LOQ-10-20.19
RECONSTRUCTION OF EXISTING SEPARATED
CROSSING WITH N.Y.C. R.R.
LORAIN COUNTY
RIDGEVILLE TOWNSHIP

TITLE SHEET	1
TYPICAL SECTION	2
CALCULATIONS-GENERAL NOTES-TABLES-GENERAL SUMMARY	3
PLAN & PROFILE	4-8
CROSS SECTIONS	9-17
BEFORE ROAD APPROACH & SIDE ROAD CULVERT	18
CULVERT & OUTLET STORM SEWERS	19
STRUCTURES OVER 20' SPAN	20-27
RAILROAD FORCE ACCOUNT WORK	28
CHANGE ORDER N° 2 (ADDED TO PLAN 12-8-52) KT	28-A, B, C.

LOR.-10-20.19
CHANGE ORDER No. 2

STATE OF OHIO DEPARTMENT OF HIGHWAYS BUREAU OF BRIDGES AND RAILROAD CROSSINGS						
PIER DETAILS BRIDGE NO. LOR-10-204 OVER NEW YORK CENTRAL R.R. LORAIN COUNTY LOR-10-20.19						
DESIGNED	DRAWN	TRACED	CHECKED	REVIEWED	DATE	REVISED
K.P.B.	M.P.B.	J.N.P.	W.C.K.	W.C.K.	12-31-51

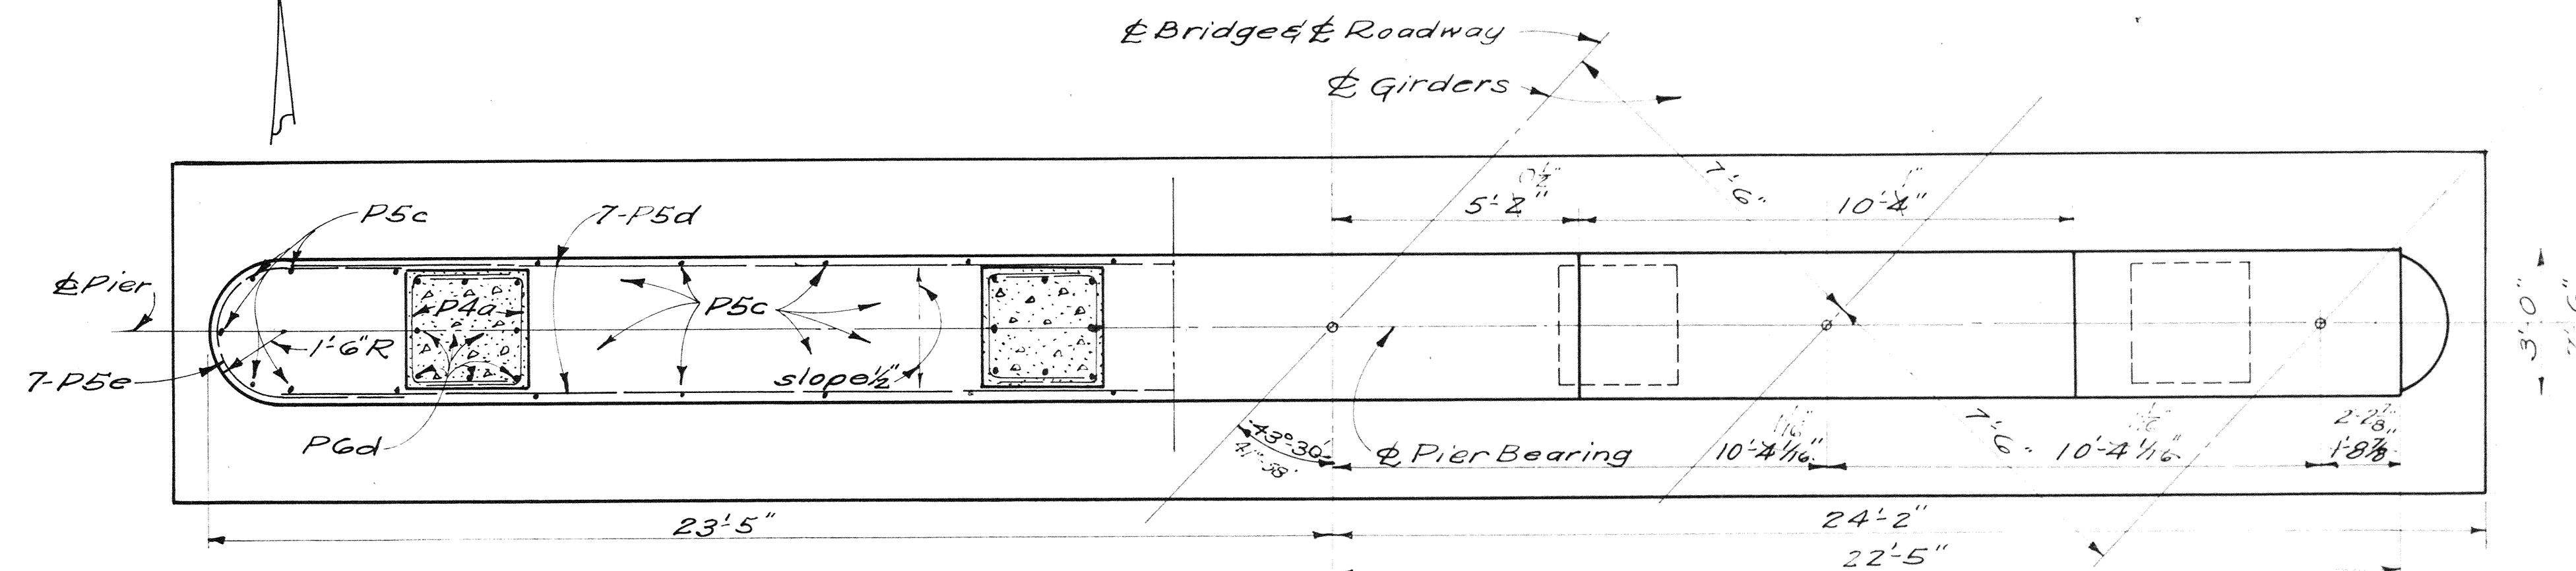
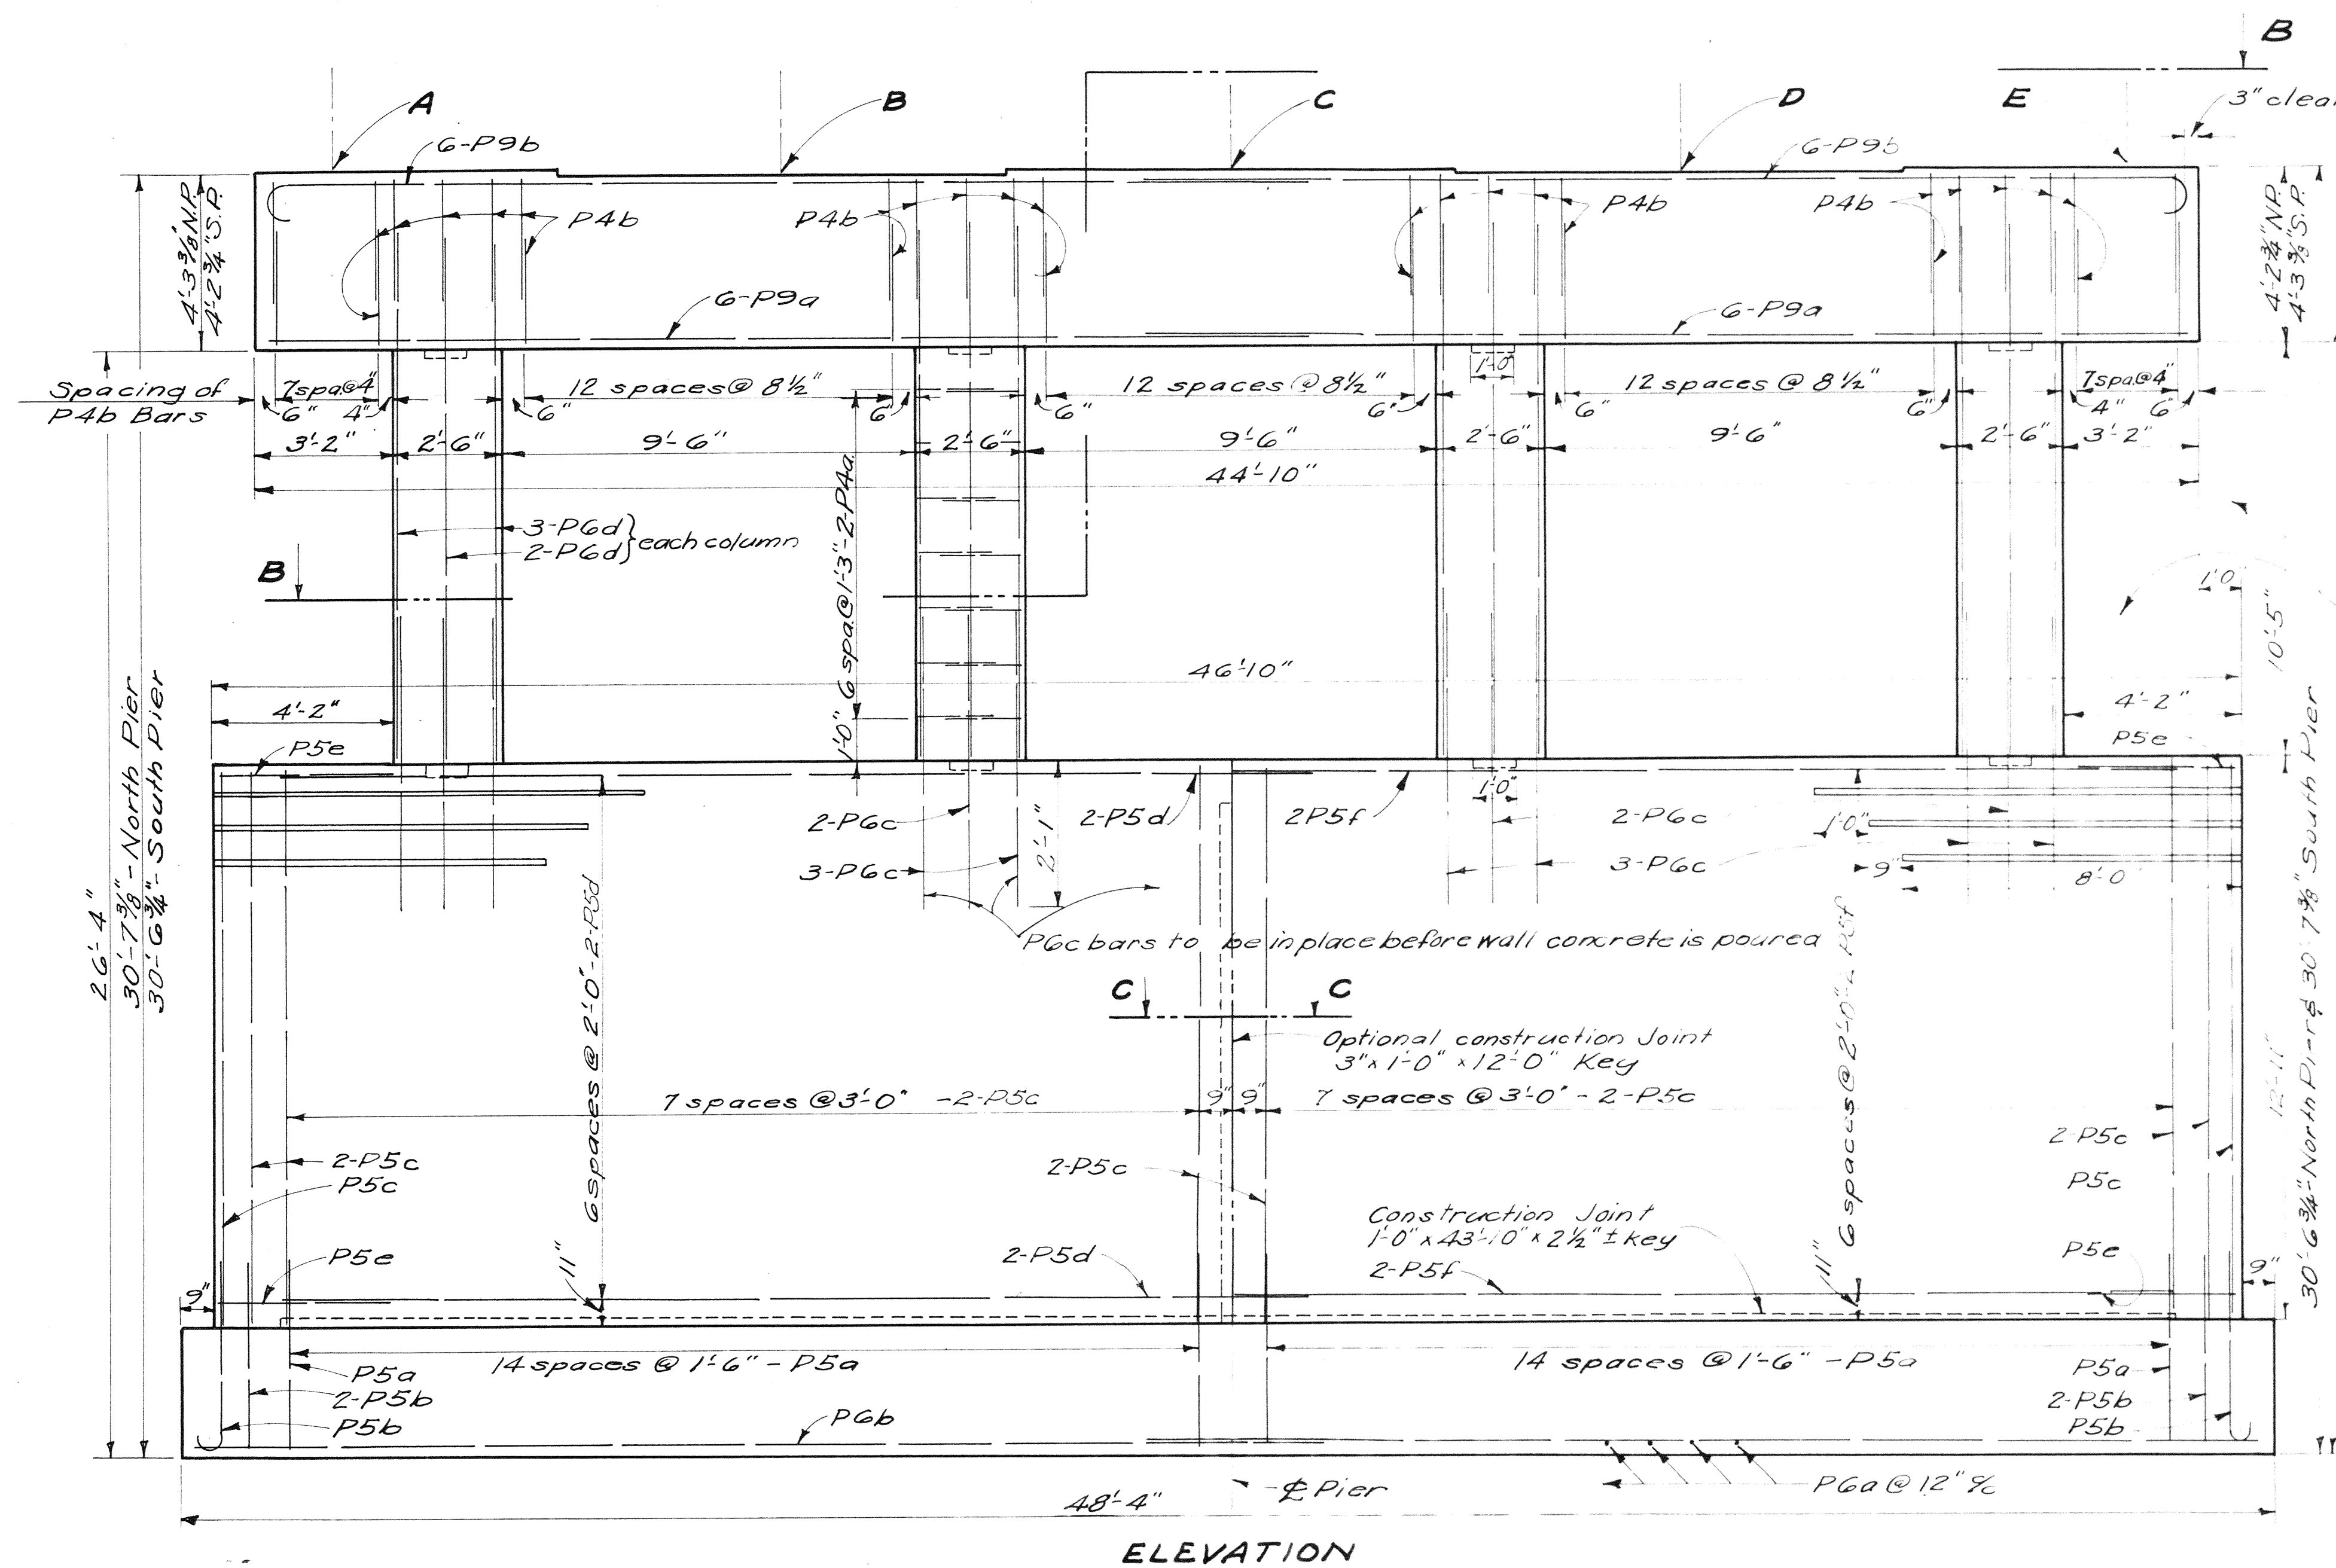
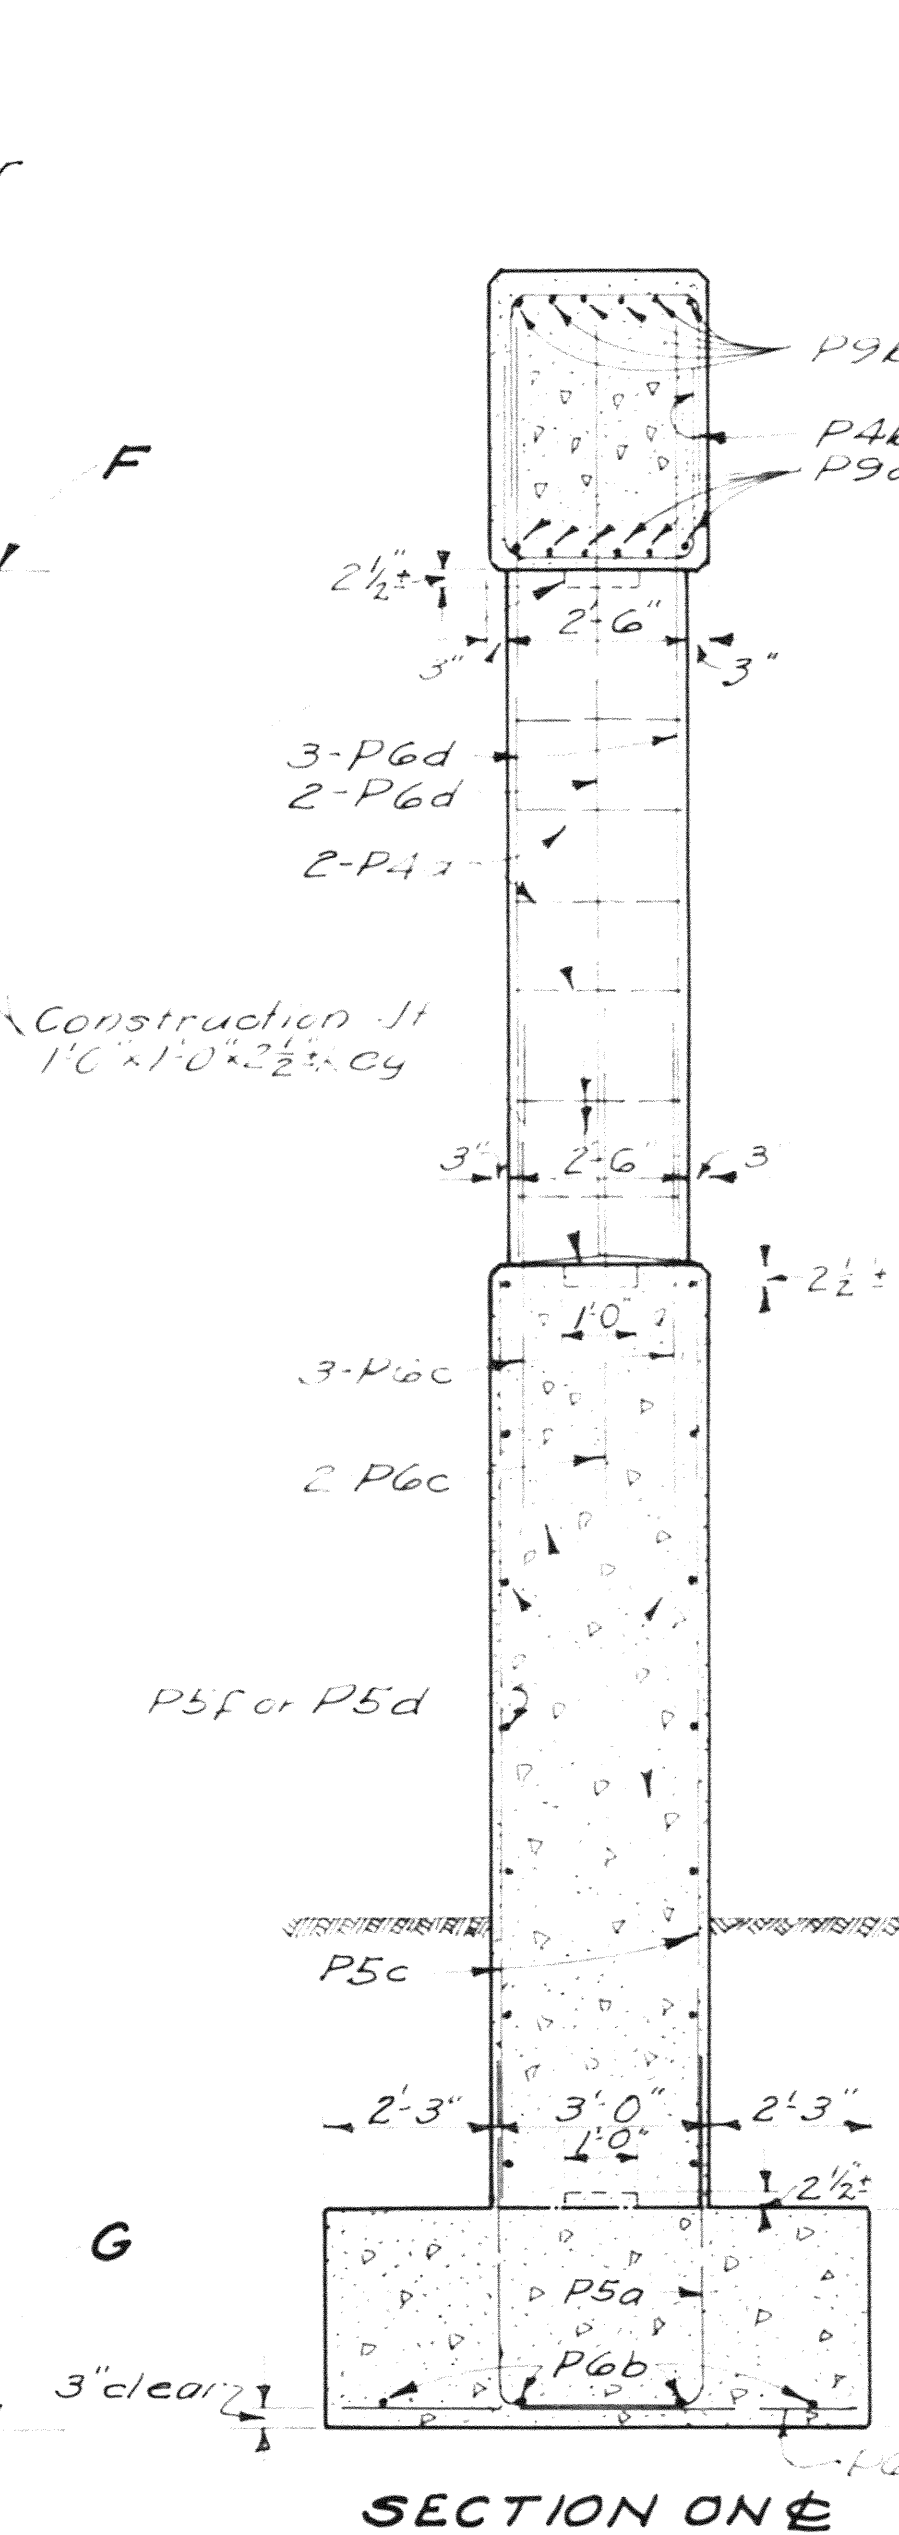
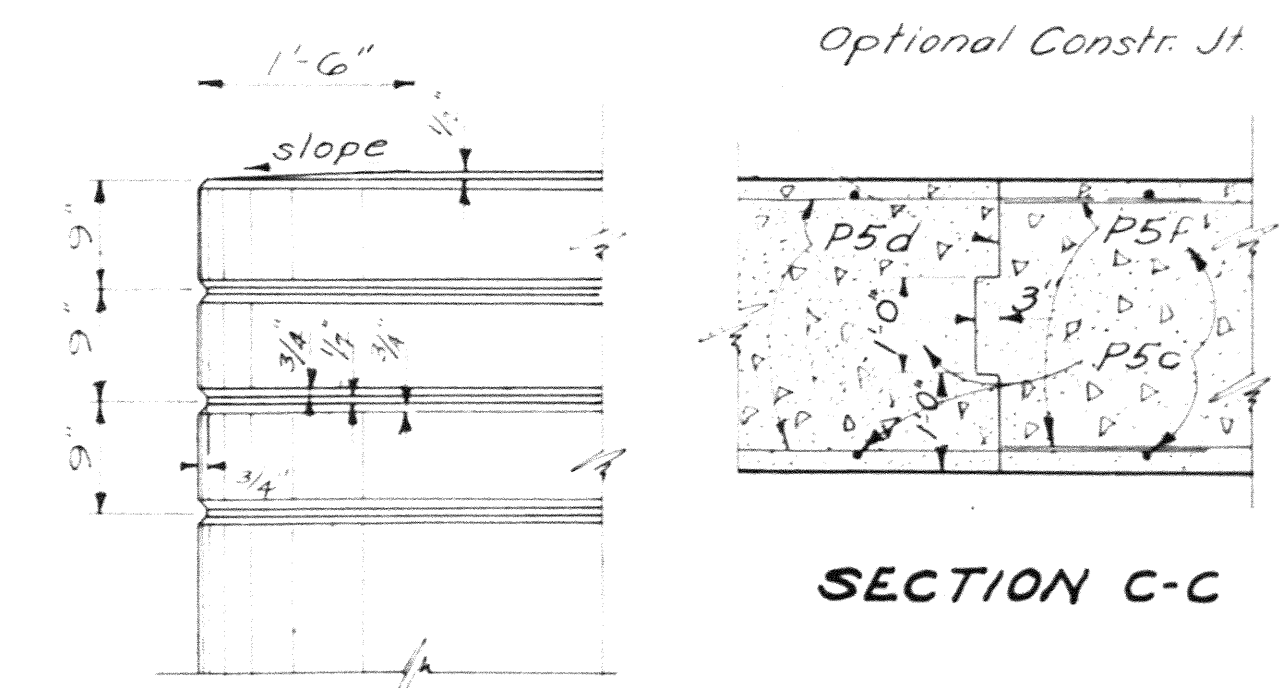
NOTE THIS SHEET REVISED 8-25-52
SHELVING ANGLE CHANGED FROM
43° 30' TO 41° 58'
